MIL-C-45360E(AT)
AMENDMENT 5
1 May 1986
SUPERSEDING
AMENDMENT 4
20 December 1984

MILITARY SPECIFICATION

CARRIERS, PERSONNEL, FULL-TRACKED: ARMORED, M113 AND M113A1; AND MORTARS, SELF-PROPELLED: 107MM, M106, AND M106A1; AND 81MM, M125A1; PROCESSING FOR STORAGE AND SHIPMENT OF

This amendment forms a part of Military Specification MIL-C-45360E(AT), dated 28 June 1978, and is approved for use by US Army Tank-Automotive Command, Department of the Army, and is available for use by all Departments and Agencies of the Department of Defense.

FIGURE 4A. Screen.

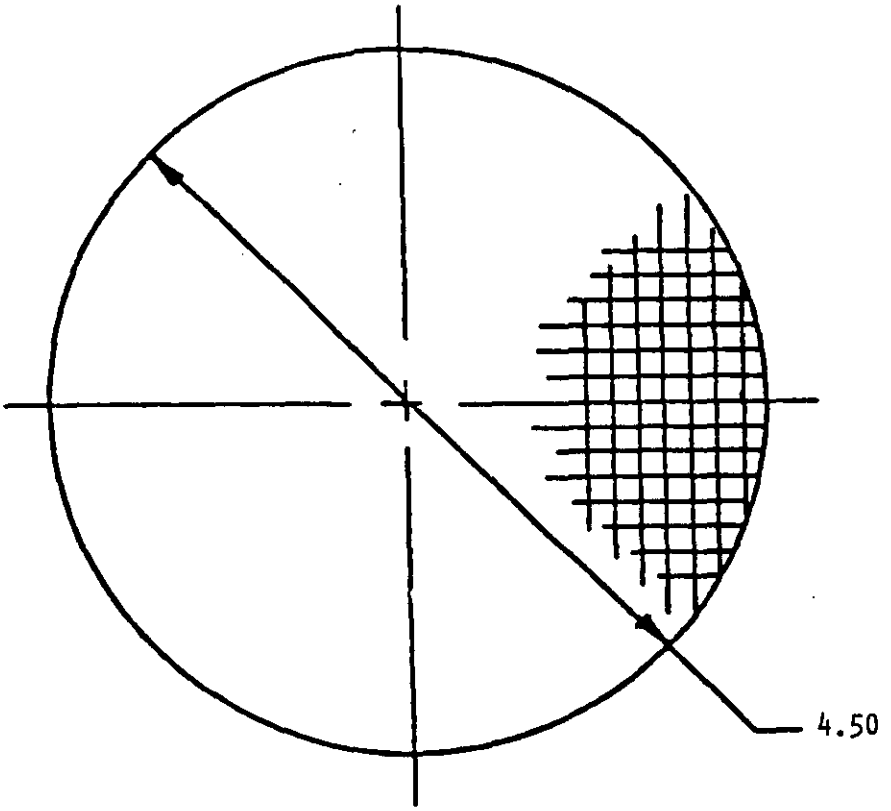
Add the following page "29-1" entitled "FIGURE 4A. Screen.", after page 29.

1. MATERIAL: WIRE CLOTH, TYPE I, CLASS 1, 4 x 4 MESH, 0.0348 DIAMETER, SPEC RR-W-360.
2. DIMENSIONS ARE IN INCHES.

FIGURE 4B. Spring retainer.

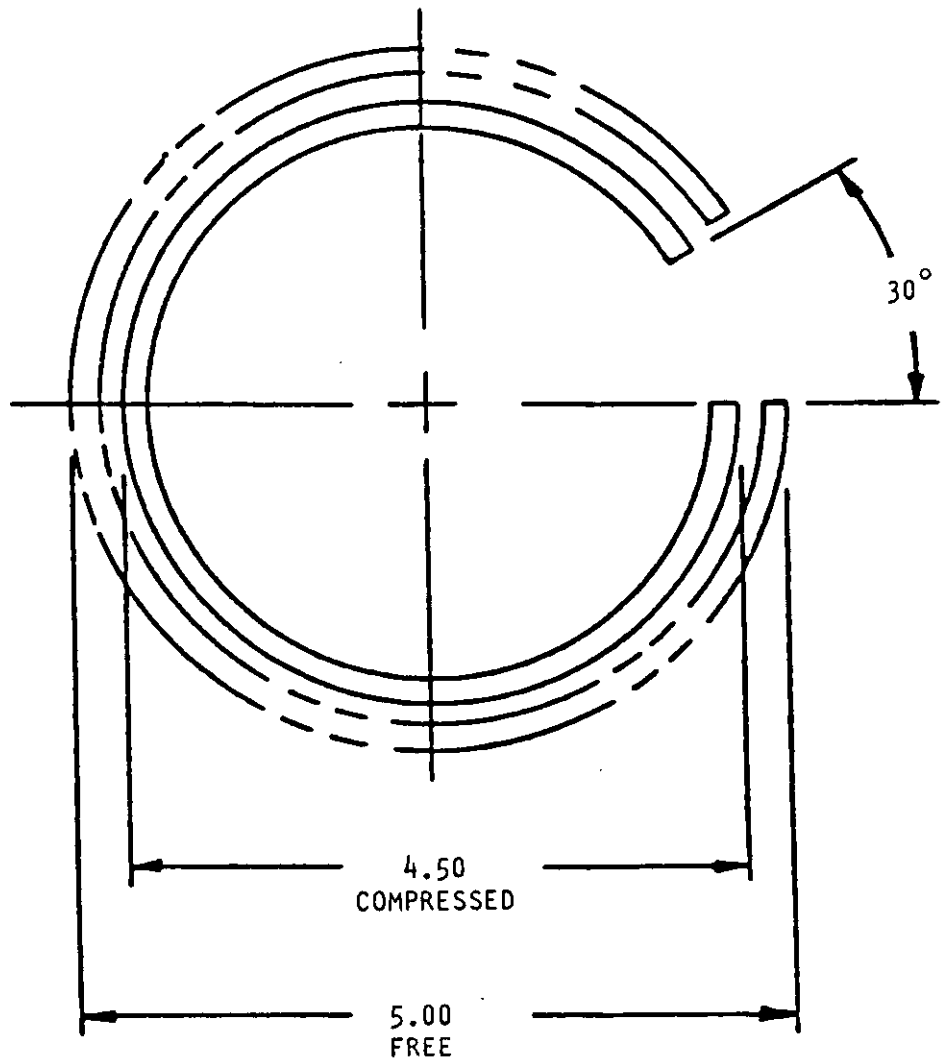
Add the following page "29-2", entitled "FIGURE 4B. Spring Retainer.", after page 29-1.

1. MATERIAL: WIRE, STEEL, MUSIC, 0.156 DIAMETER, SPEC QQ-W-470.
2. DIMENSIONS ARE IN INCHES.
